COMMUNITY DEVELOPMENT DEPARTMENT REPORT

HEARING DATE: 10/1/2026
TO: Planning & Zoning Commission
FROM: Nick Napoli, Associate Planner
208-884-5533
nnapoli@meridiancity.org
APPLICANT: Amanda McNutt
SUBJECT: Momentum Subdivision
H-2026-0036

LOCATION: Generally located at the southeast corner of Meridian Road and Lake Hazel in the east ½ of the northwest ¼ of Section 6, T.2N., R.1E.

C. Previous and Current Concept Plan (date: 8/19/2026)

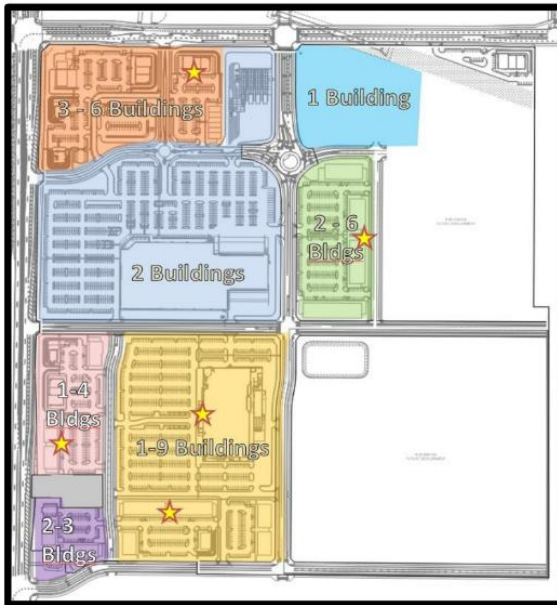
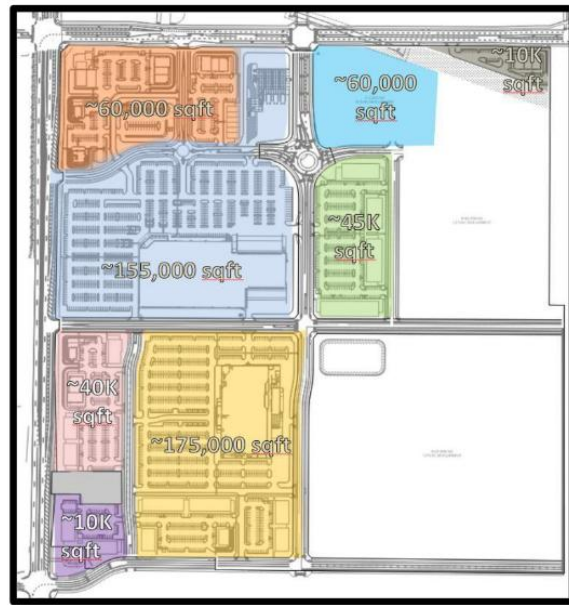
- The applicant provided an illustrative concept plan for the proposed map amendment; however, they are asking not to be tied to this concept plan as they would like the flexibility to change building locations, square footage, plaza locations, curb cuts, and number of buildings as market demands change. In addition, no concept plans were submitted for the residential portion.

For rezones city code requires the applicant to provide a conceptual development plan that depicts streets, site access, internal circulation patterns, connectivity to adjacent properties, parking, general location of buildings, including number of dwelling units and nonresidential building square footages, pedestrian walkways, and public or private open space. The recorded DA also requires an updated concept plan consistent with the FLUM designations. Although some flexibility is supported by staff, additional changes are warranted to ensure consistency with the existing and proposed FLUM designations. Therefore, the applicant

Staff has concerns that the level of detail and flexibility requested with the concept plan makes it difficult to evaluate whether the proposed R-40 zoning is appropriate in the context of the overall development. In particular, the concept plan does not provide sufficient certainty regarding residential density, site design, connectivity, transitions between residential and non-residential uses, and the integration of the proposed R-40 area with the surrounding mixed-use development.

The UDC requires large multi-building developments requires a minimum of forty (40) percent of buildable frontage to be occupied by building facades and/or public space. The applicant's concept plan does not comply with the requirement. As a result, staff is including the following provision in the development agreement: "For mixed-use developments, a minimum of 40% of the buildable frontage must be occupied by building facades or public space. This is required along all public roads."

15 Days Prior to the City Council hearing, the applicant shall provide a revised concept plan with the changes listed below.

- k. Revise the concept plan with the following changes:
 - A minimum of six (6) plazas or shared open space be incorporated throughout the development with two (2) focal areas being in Lots 11 and/or 12, Block 1 and Lots 8 and/or 9, Block 2

D. Landscape Plan (date: 8/19/2026)

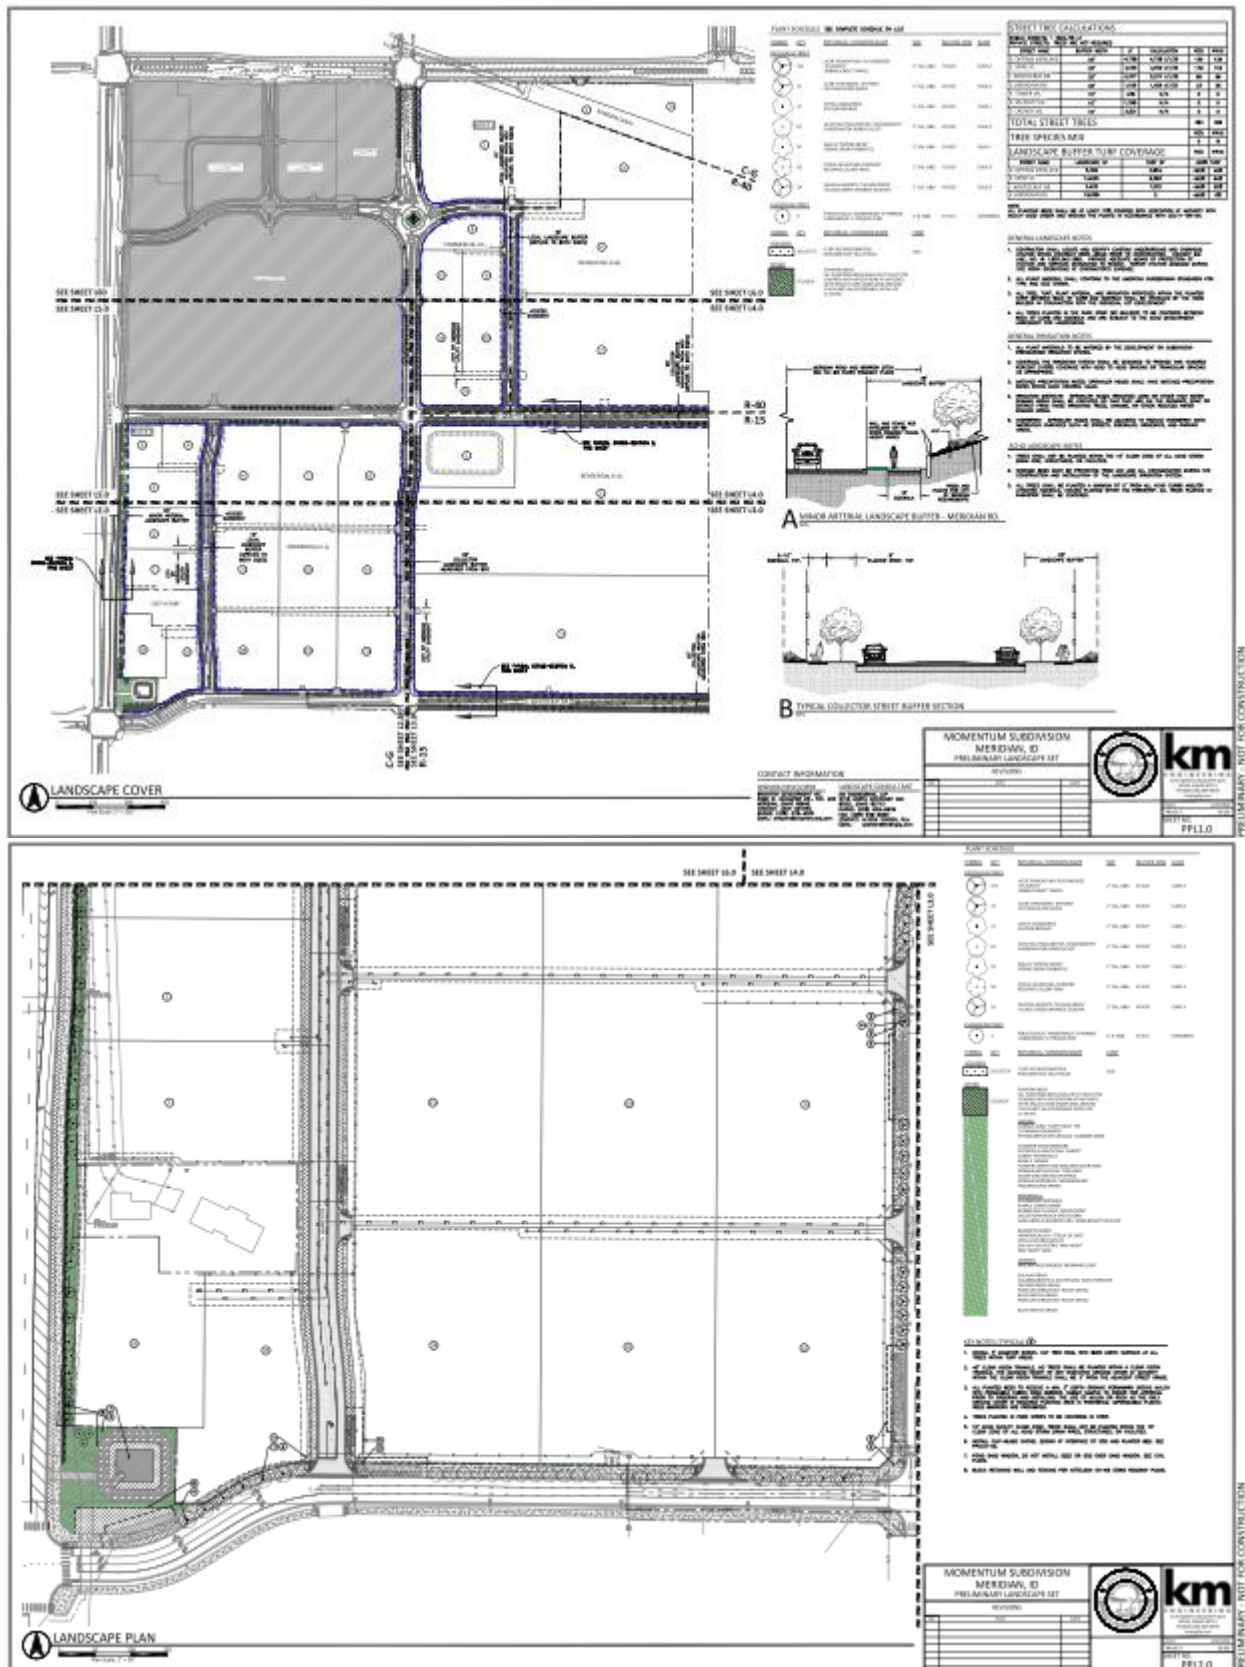
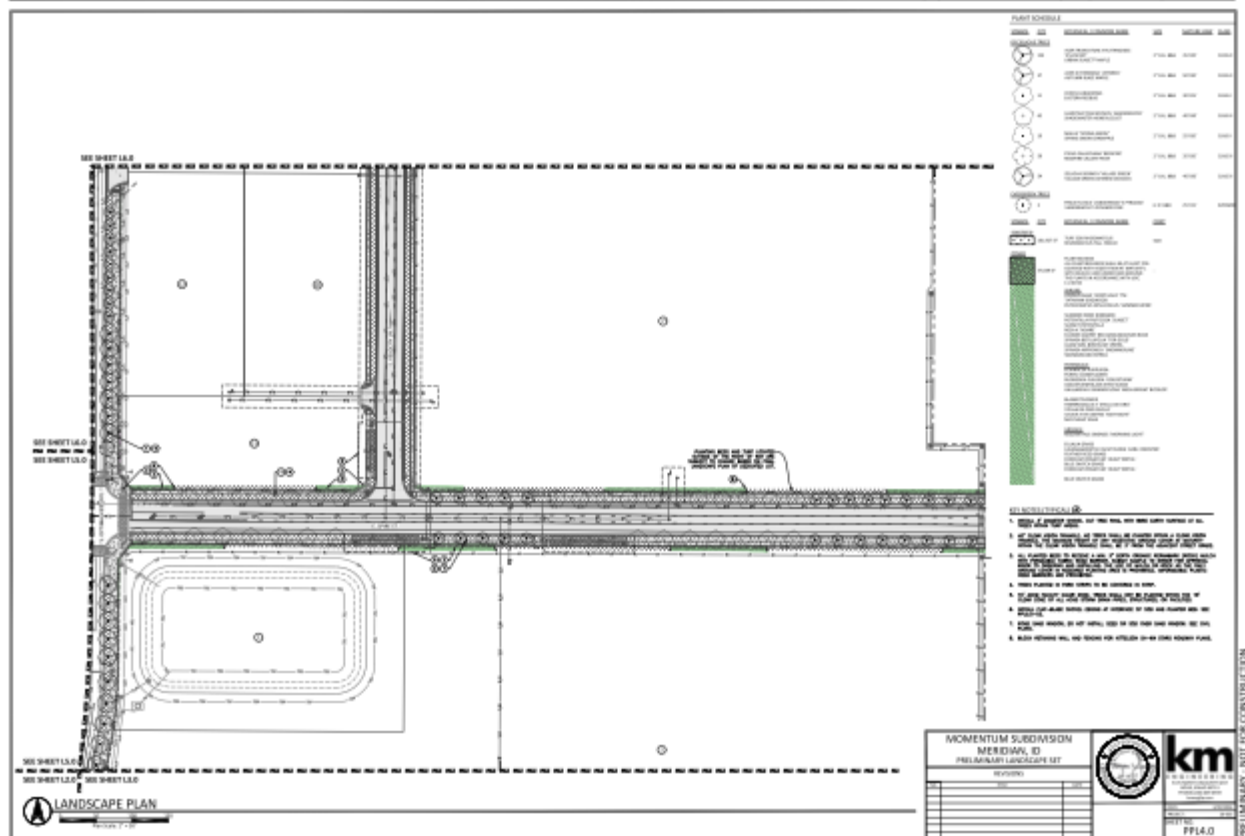
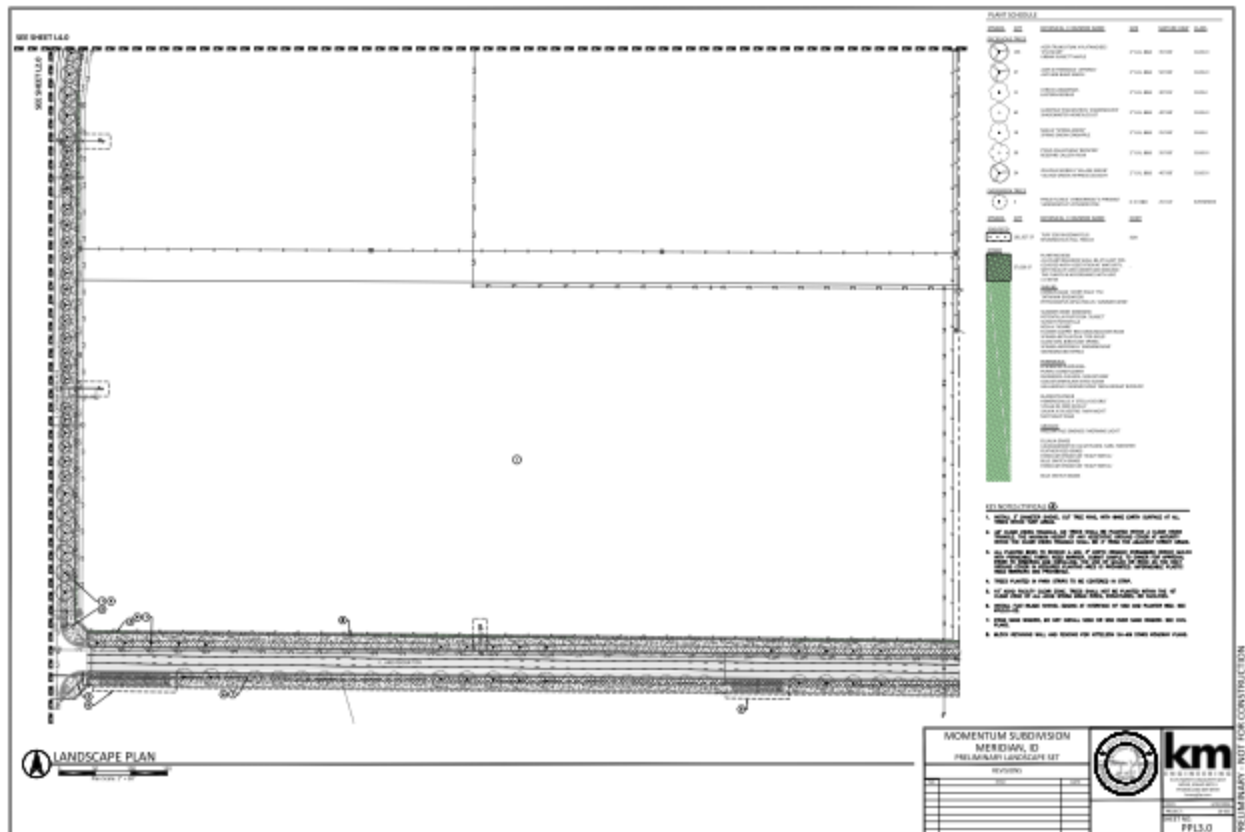
UDC Requirement	Proposed/Analysis
Entry Way Corridor: 35 Feet	Along Meridian Road/SH-69 the applicant is proposing a 35-foot-wide landscape buffer. However, the preliminary plat shows a significant portion of the landscaping is proposed to be inside of the right of way. The applicant shall provide a license agreement with the transportation authority to certify the entire landscape buffer will meet UDC requirements.
Arterial Road: 25 Feet	The applicant is not proposing the required 25-foot landscape buffer along Lake Hazel Road as required in the UDC. The applicant shall revise their landscape plan with the final plat to show the 25-foot landscape buffer along Lake Hazel Road in Lots 1, 2, and 3, Block 1.
Collector Road: 20 Feet	The preliminary plat shows a 20-foot landscape buffer along E. Spire Street; however, S. Optimum View Avenue and E. Aristocrat Drive do not show the full 20-foot landscape buffer. The applicant shall revise this with the final plat application. In addition, the southern half between Spire Street and Aristocrat Drive borders the future extension of the north/south collector. The applicant does not depict the landscape buffer along this road. This shall be revised with the final plat(s) for the R-15 portion of the site.

UDC 11-3A-17 requires parkways of a minimum width of 8 feet. The applicant has indicated in their narrative that the parkways are 8 feet in width, however it is not dimensioned on the landscape plan. These parkways are provided along the private streets within the development alongside the five (5) foot sidewalks. The parkways shall be dimensioned and a minimum of 8 feet in width in the final plat application.

- c. A portion of the landscape buffer is inside of the Rawson Canal easement which may affect vegetation coverage. If vegetation coverage requirements cannot be met, the applicant shall apply for alternative compliance with the final plat application.
- d. Provide 5 feet of landscaping on the back side of all multi-use pathways.
- e. Show the full 20-foot landscape buffer along S. Optimum View Avenue and E. Aristocrat Drive.
- f. Show the required 20-foot landscape buffer along the future North/South Collector along the east side of Lot 6, Block 1 and Lots 4 and 5, Block 3.

- 3. The landscape plan submitted with the final plat shall include the following revisions:
 - a. Show the 25-foot landscape buffer along Lake Hazel Road in Lots 1, 2, and 3, Block 1 and include vegetation coverage meeting UDC 11-3B-5 and UDC 11-3B-7.

- b. Include mitigation calculations on the plan for existing trees that are proposed to be removed in accord with the standards listed in UDC 11-3B-10C.5. The Applicant

H. Pedestrian Connectivity Plan

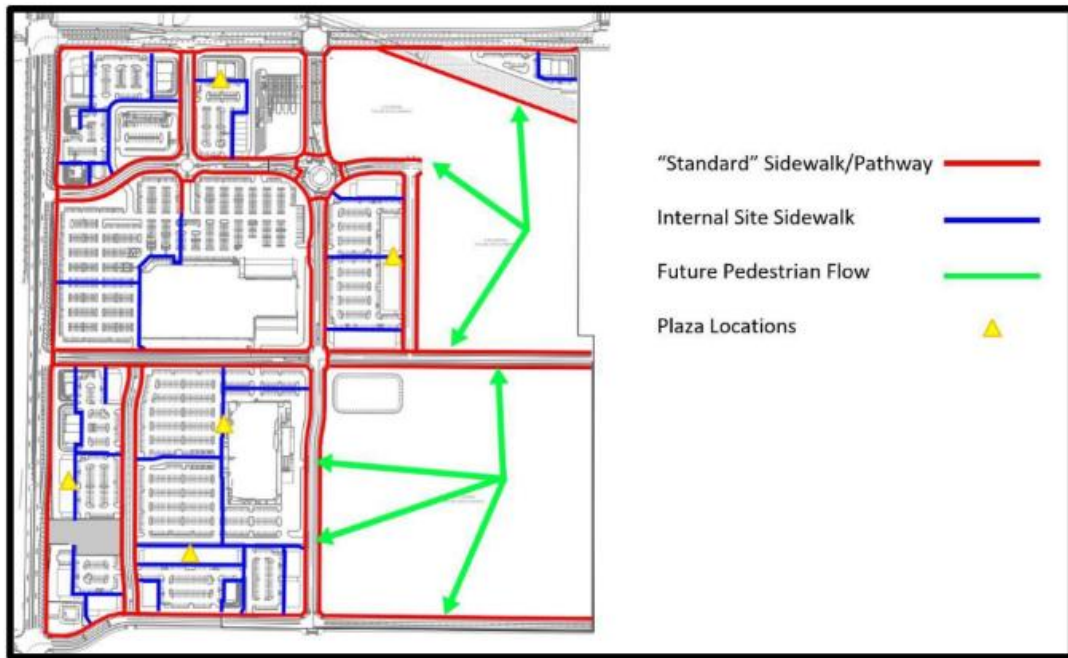
To improve pedestrian connectivity between the residential and commercial areas, staff recommends requiring mid-block pedestrian connections through the development. Specifically, connections should be provided from Lot 7, Block 1 to Lot 10, Block 1, and from Lot 2, Block 3 to Lot 9, Block 2. These connections would improve internal pedestrian connectivity and help ensure that future development supports the connected, integrated pattern envisioned for the MU-R designation.

The applicant provided a pedestrian connectivity plan with their submittal. The plan shows all multi-use pathways and sidewalks that are planned for the development. However, since a concept plan for the residential portion was not provided, the applicant has not provided clear pedestrian connections from the residential to the commercial uses in the development. As a result, staff recommends requiring mid-block pedestrian connections through the development. Specifically, connections should be provided from Lot 7, Block 1 to Lot 10, Block 1, and from Lot 2, Block 3 to Lot 9, Block 2. These connections would improve internal pedestrian connectivity and help ensure that future development supports the connected, integrated pattern envisioned for the MU-R designation.
